BRIEFING SUMMARY SHEET

DEVELOPMENT ASSESSMENT CASE NUMBER: CD-2016-0010

REQUEST: Presentation of a Development Assessment Report for the 425 W. Riverside Drive Planned Unit Development (PUD), located at 425 W. Riverside Drive, within the Lady Bird Lake watershed.

Project Name: 425 West Riverside Drive PUD
Address: 425 W Riverside Dr
File Number: CD-2016-0010

01 SECTION A - THROUGH SOUTH FIRST STREET FACING NORTH

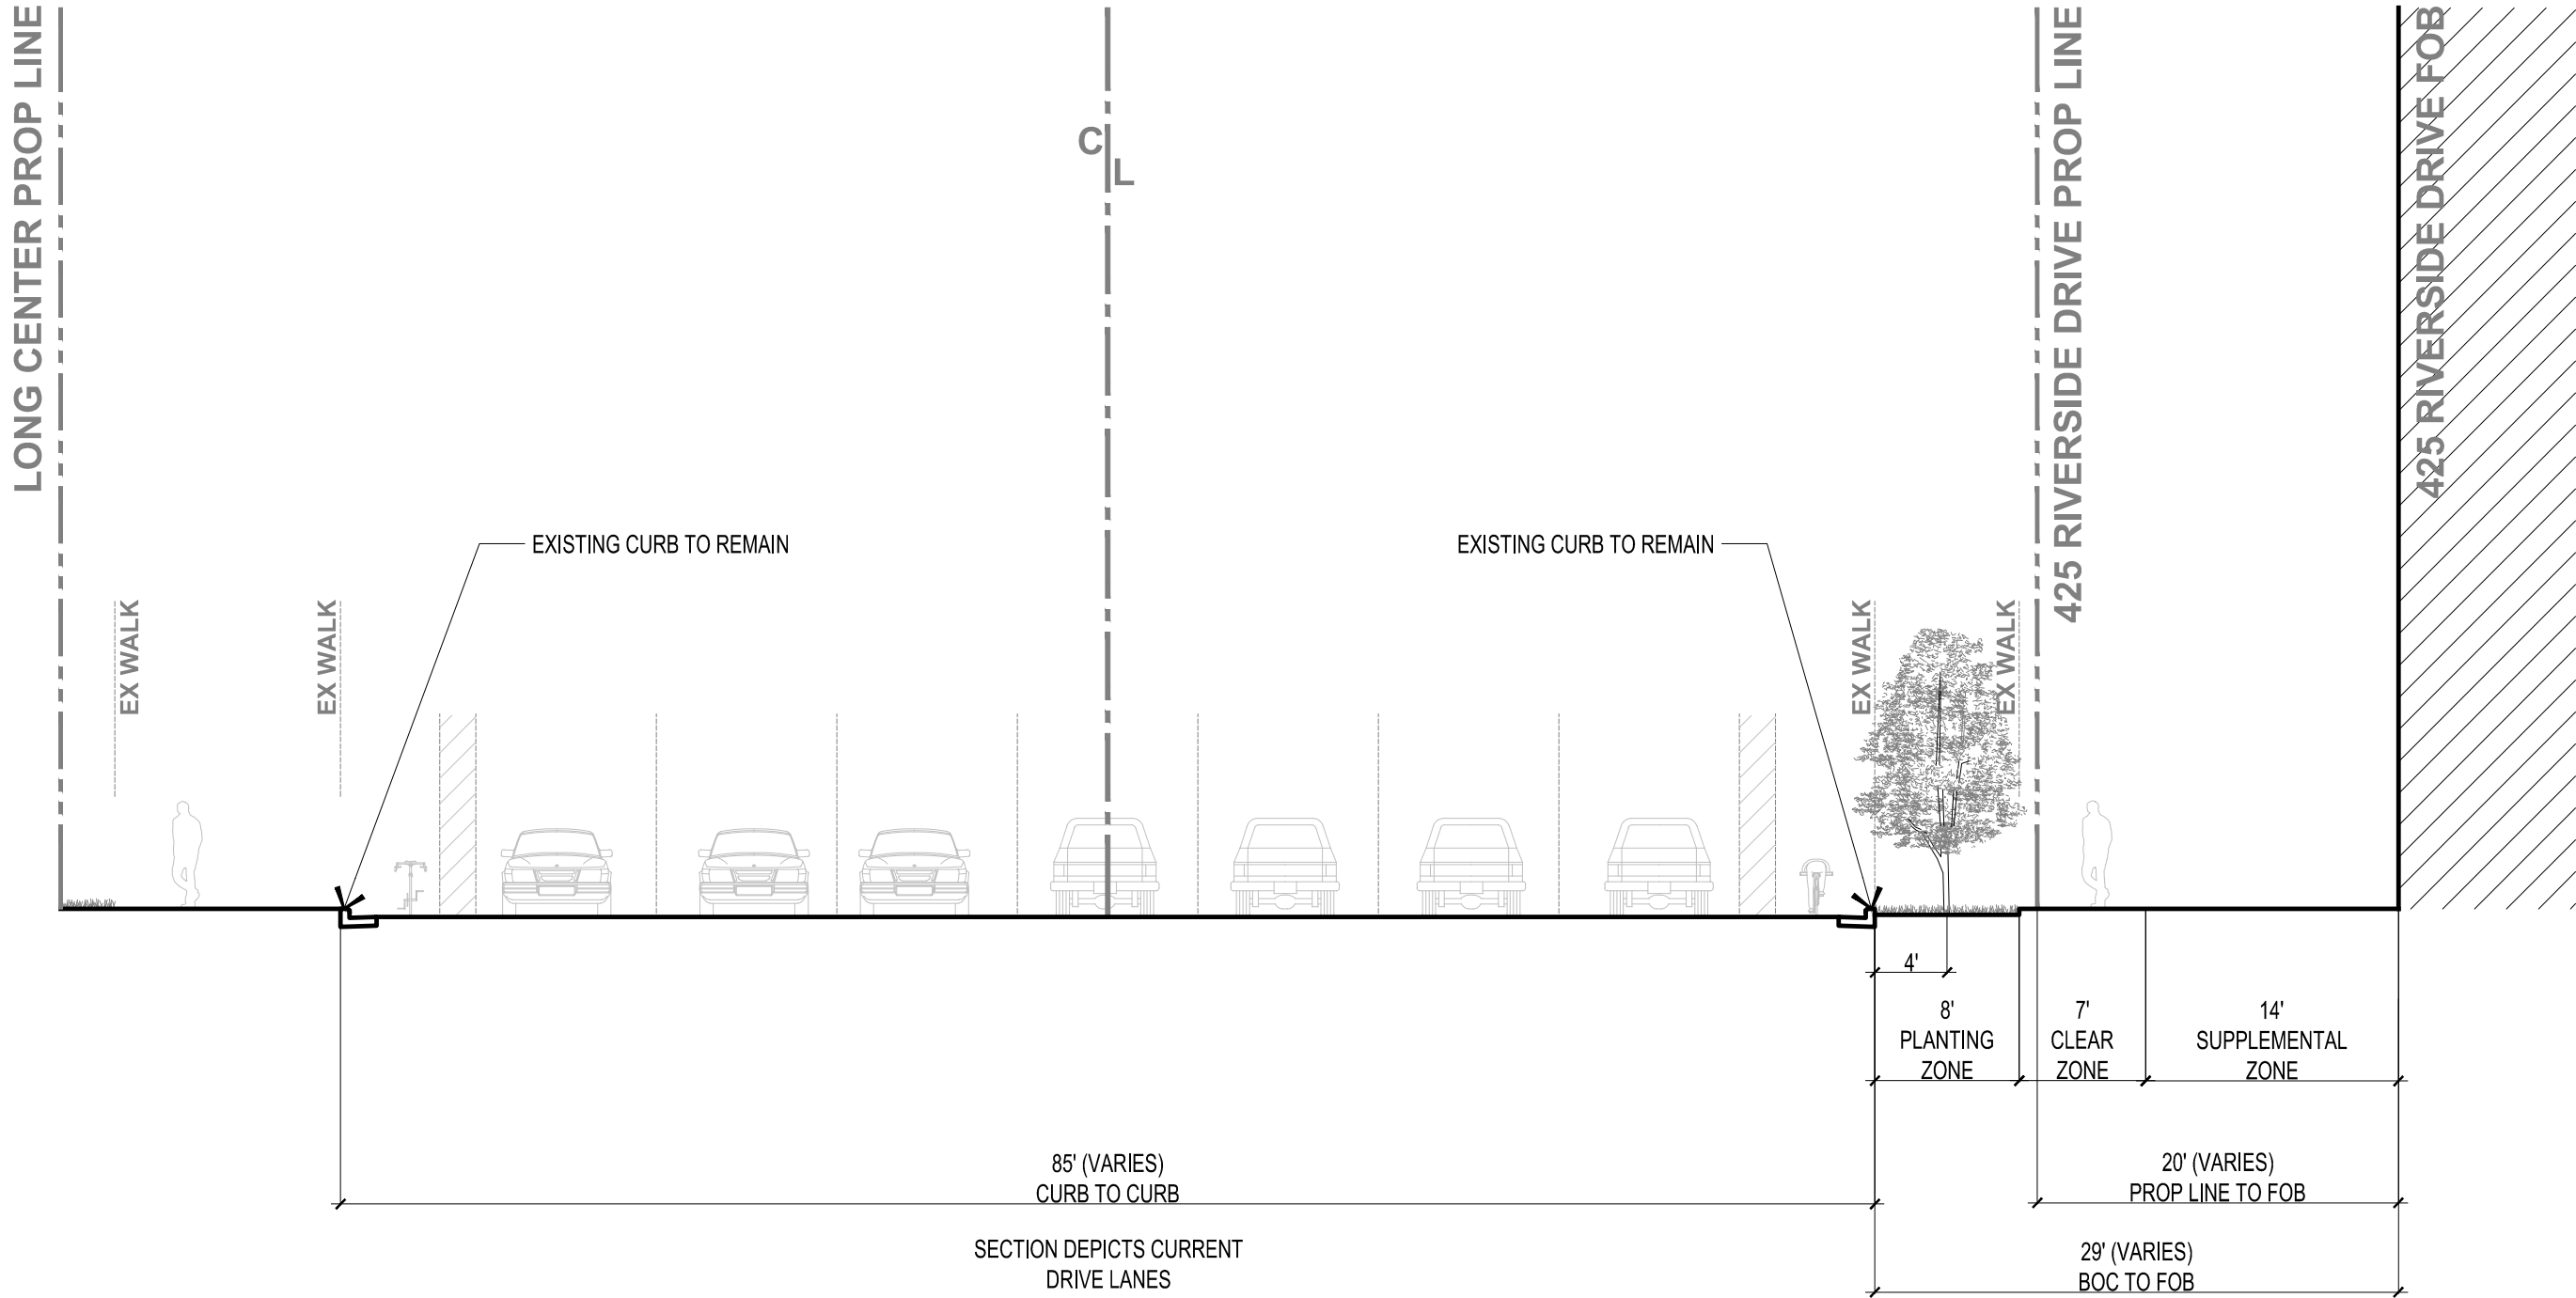
- TR1. Requirement 2.3.1.G Public Facilities:
- TR2. Requirement 2.3.1.1: Transportation Connectivity: Please consult with Capital Metro regarding the square footage required to provide an open space area for the adjacent bus stop. 4: Revise “Commercial Design Standards” with “Core Transit Corridor Standards”.
- TR3. Requirement 2.3.1.J Prohibit Gated Roadways: Revise the requirement to state “gated roadways are prohibited”.
- TR4. Requirement 2.3.2.B Commercial Design Standards: Specifically clarify how the PUD will comply with and/or exceed Core Transit Corridor Standards.
- TR5. Requirement 2.3.2.C Commercial Design Standards: Specifically clarify how the PUD will comply with and/or exceed the pedestrian-oriented use requirement on the first floor of the building.
